HUNTER'S PARK SUBDIVISION, UNIT IV

APPLICATION NUMBER 8 DATE January 19, 2006

REQUEST Subdivision

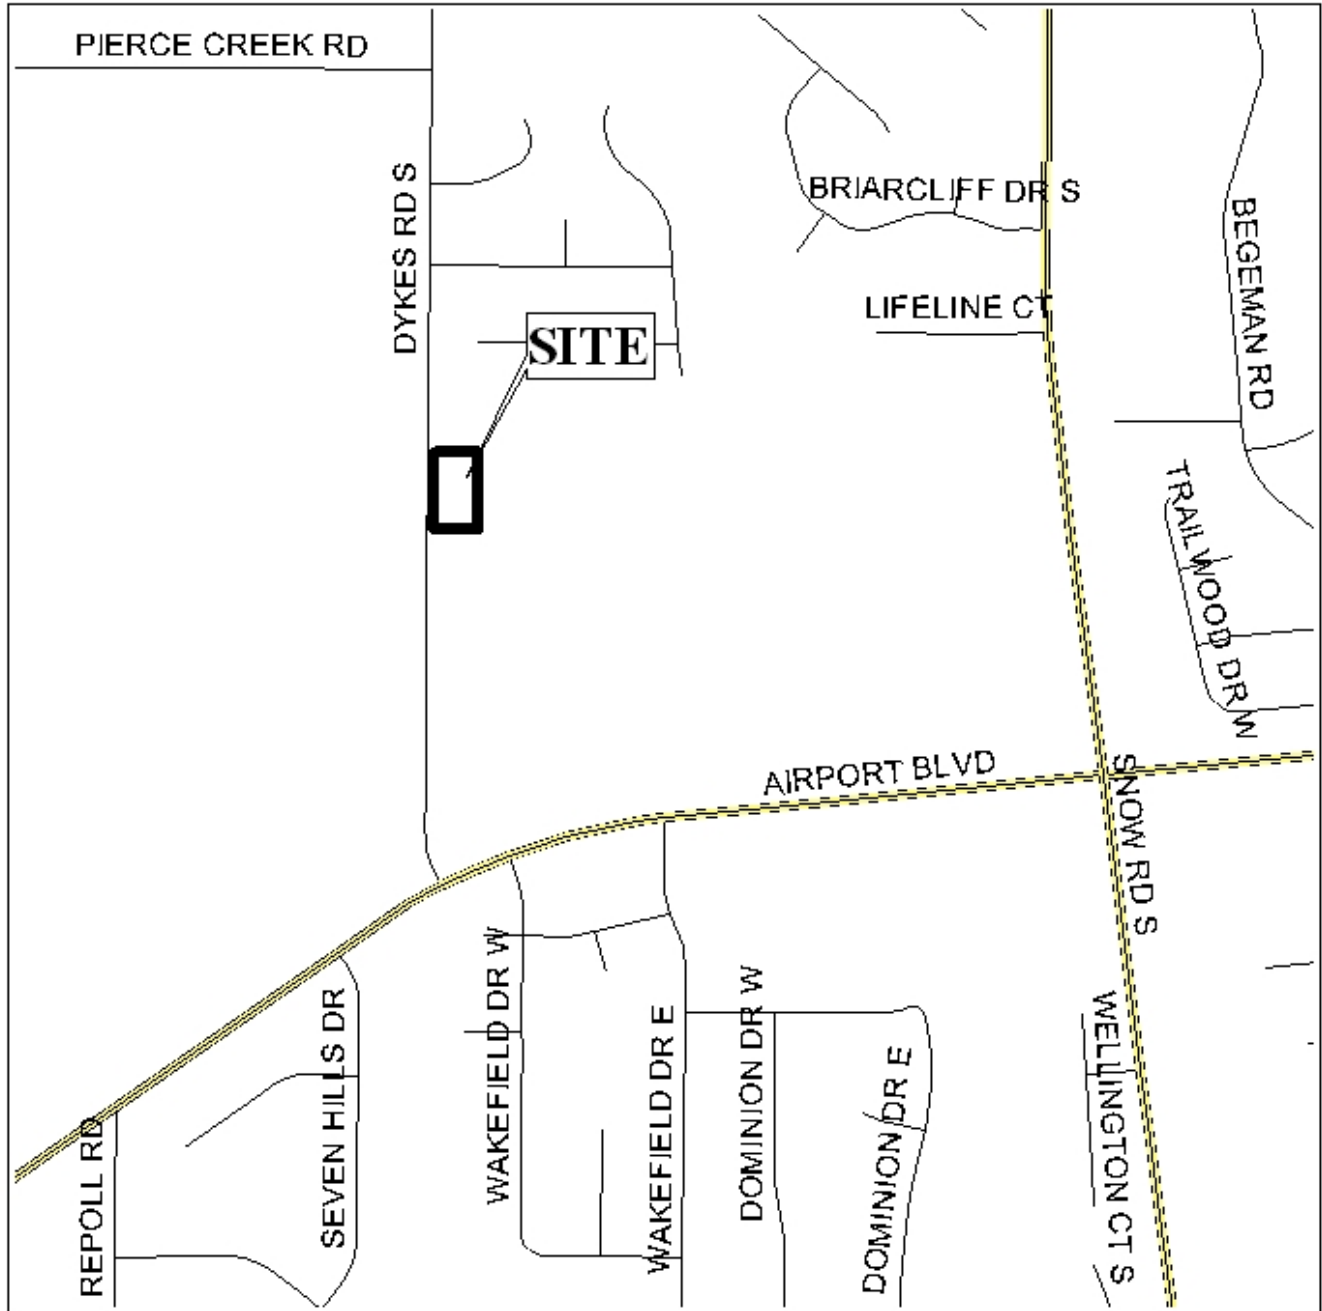
Engineering Comments: Must comply with the Mobile County Flood Damage Prevention Ordinance.

The lots meet the minimum requirements of the Subdivision Regulations, but the site, adjoining several existing and proposed residential developments, presents some issues and opportunities regarding street connectivity.

Unit IV would prevent the proposed East-West street in Unit V from connecting to Dykes Road South, which is an undesirable outcome for the site. Minor street connections benefit neighborhoods by allowing dispersion of traffic, more access points for emergency vehicles, and more efficient distribution of roads and utilities; this site presents unusually good opportunities to increase the connectivity of existing and proposed neighborhoods.

The Unit V plat illustrates a stub North connecting to Summerlake and one West to Unit III. By extending the proposed East-West cul-de-sac to Dykes Road South through the subject property, traffic would be alleviated for adjoining streets in Hunter's Park and Summerlake, and the neighborhood would become more accessible by emergency vehicles.

Based on the preceding, it is recommended that this application be held over to the February 2nd meeting, to allow the applicant to coordinate the design of Unit IV with that of Unit V, to increase the connectivity of the streets. Revised materials should be received by January 23rd.
